Reference: U.S. Geological Survey TRIGA Reactor (GSTR), Docket 50-274, License R-113,
Request for Additional Information (RAI) dated October 2, 2012

Subject: Responses are provided to Questions of the subject RAI

9. Please provide the results of the GSTR neutronic analysis showing:

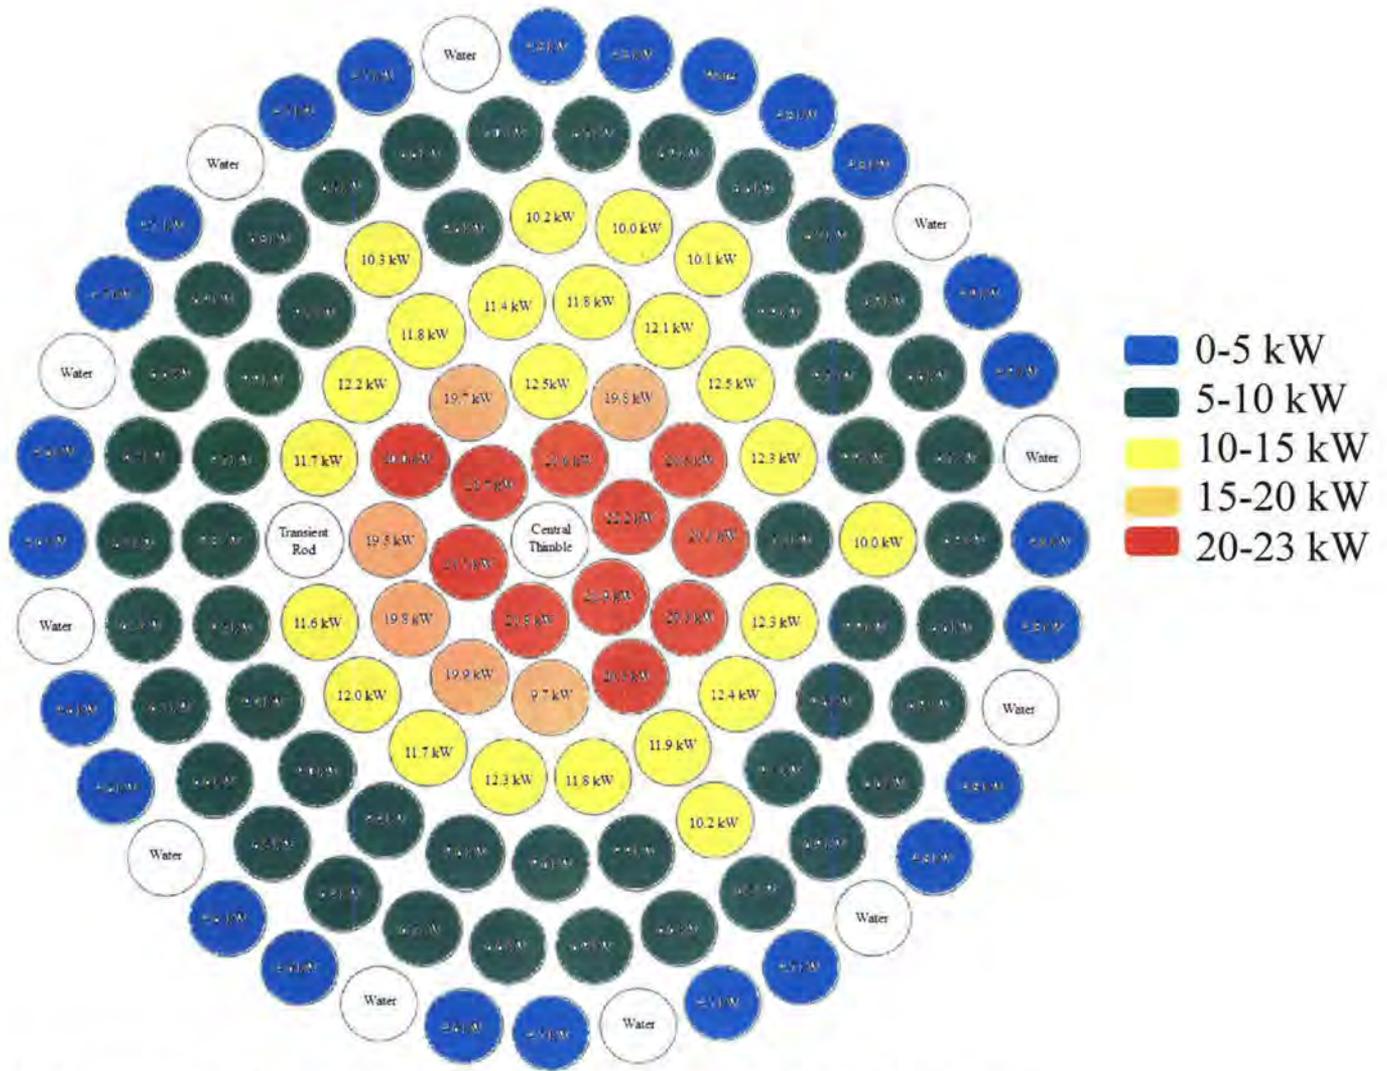
- The comparison of the ρ_{excess} and the control rod worths calculated and measured from the OC

Shim 1	Shim 2	Regulating	Transient
Calculated Worth (\$)	2.28	2.38	3.56	2.17
Experimental Worth (\$)	2.305	2.435	3.630	2.142

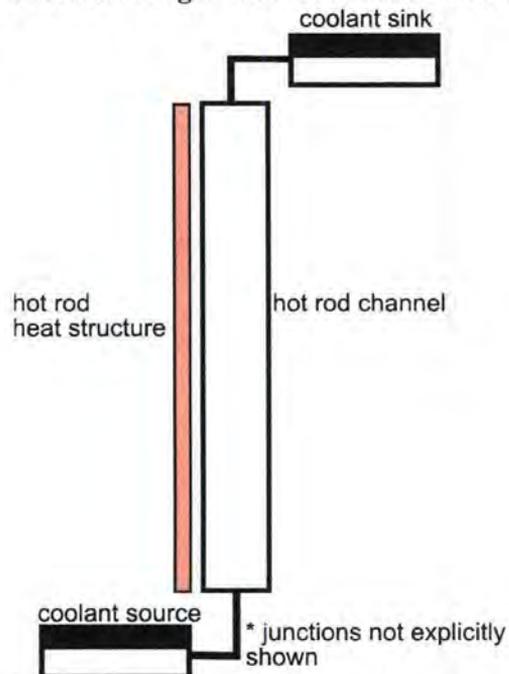
- **Provide a diagram of the RELAP model**

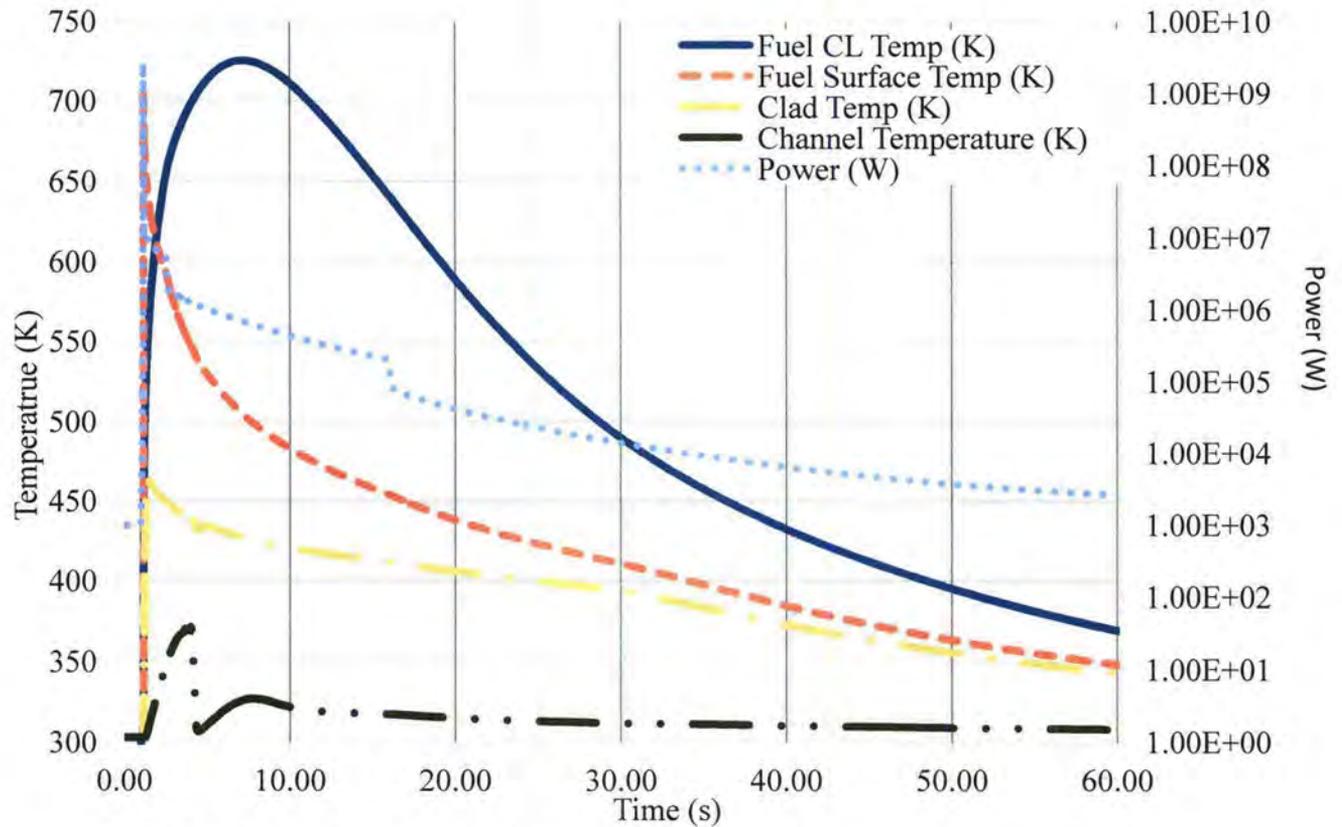
- **Document the RELAP model calculated results such as the core flow rate, peak fuel and cladding temperatures, the location of the minimum DNBR, and the value of the minimum DNBR using the Bernath correlation**

Core flow rate: ~0.10686 m/s

Peak Fuel Temperature: 829.32 K (556.17 C)

Peak Cladding Temperature: 410.04 K (136.89 C)

MDNBR: 2.15 @ 0.392133 from the bottom of the fuel element

Figure 17.1 Top and side views of the model for calculating the scattered dose in the SE corner after a LOCA

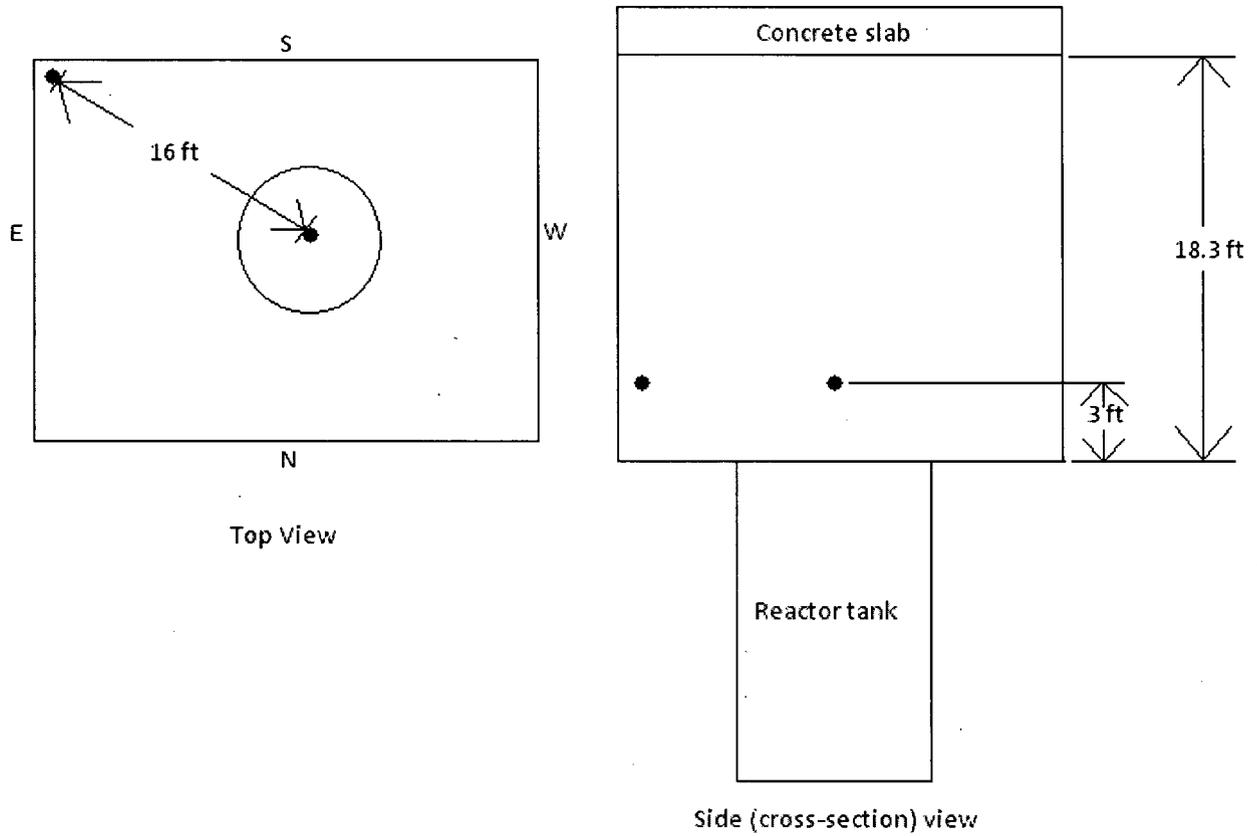
- The parameters used in determining the scattered dose at the fence line location (about 259 meters from the center of reactor bay). This should include all data and calculations with and without the credit for the 1 ft concrete wall of the reactor bay.
- In response to RAI 15.3, the fence line distance to the reactor bay is identified as 350 meters, as opposed to 968 feet in the response to RAI 17.1. Provide the dose calculations based on a consistent value of the distance to a member of the public.
- The analysis of offsite dose was limited to one location beyond the GSTR fence line, and did not consider locations within the owner controlled area between the fence line and the reactor bay (e.g., parking lot, office locations, etc.) where individuals

The second point of interest for calculating the effective dose equivalent rate is located in the SE corner of the reactor bay, 3 ft above the floor, and 16 ft away from the vertical line intersecting the center of the core. This point is the furthest distance a person can get from the edge of the reactor and remain in the reactor bay. The ceiling immediately over the reactor tank is a staggered ceiling with a steel access hatch and concrete support. To yield a conservative dose calculation it will be modeled as a concrete slab located 18.3 ft above the floor of the reactor bay. In reality the scattering will not be as great as calculated because the radiation from the unshielded core will undergo less interaction with the roof. A representation of this model is shown in Figure 17.1. The initial assumptions from Section 13.2.3.2.3 will be used once again: the basic assumption for the calculations is that the reactor has been operating at a maximum power level of 1 MW for one continuous year, and then the cooling water is instantly lost. This is a very conservative assumption; since there is no conceivable way the GSTR could be operated continuously, 24 hours per day, at 1 MW for one year, nor is there any way all of the cooling water could be instantly lost. The GSTR normally operates on an 8-hour-per-day shift for 5 days per week. The reactor core, shutdown and drained of water, was treated as a point source of 1-MeV photons. No accounting was made of sources other than fission product decay gamma rays, and no credit was taken for attenuation through the fuel, fuel element end pieces, and the upper grid plate. The first of these assumptions is optimistic, the second conservative, and the net effect is conservative. The calculations for the flux of gamma rays, Equation 1, and the source term strength, Equation 2, from section 13.2.3.2.3 will be used again in this analysis.

For the dose position of interest, we are looking at gamma rays that are scattered at an angle of 46.28° , and travel a total distance of 22.1 ft (673.6 cm) from the scatter point to the position. A representation of this geometry is shown in Figure 17.2. Gammas that have an initial energy of 1 MeV and are scattered according to Figure 17.2 have a scattered energy calculated by [1]

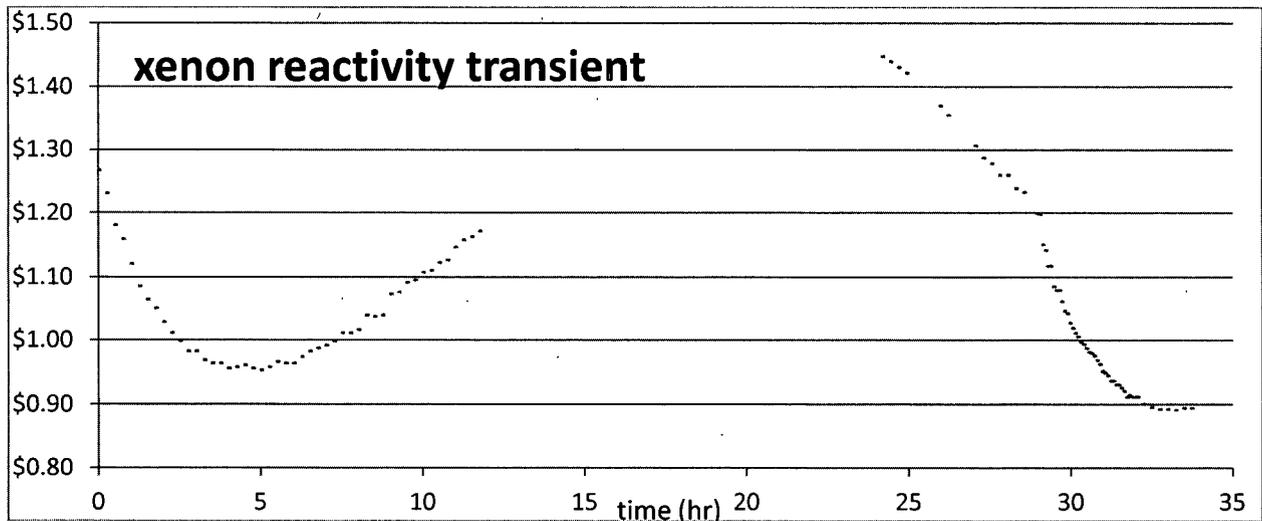
23.1 The response to this RAI does not provide criteria for determining what constitutes a significant change in core configuration. Please provide and justify the criteria chosen.

Significance is determined by the potential for violation of Technical Specifications. This could occur, for example, when core fuel loading is changed or an in-core experimental facility is moved, especially when that change is near a control rod location. Loading or unloading of experiment samples is not normally considered sufficient reason for requiring control rod recalibration. When a relatively large shutdown margin exists, the potential for Technical Specification violation is significantly reduced. Therefore, if a numeric value must be assigned to "significance", we propose that a significant change be defined as a positive reactivity change of at least one-half of the shutdown margin that exists prior to the change.

For example, if the shutdown margin is \$1.30, then a positive reactivity change of \$0.65 or more would constitute a significant change.
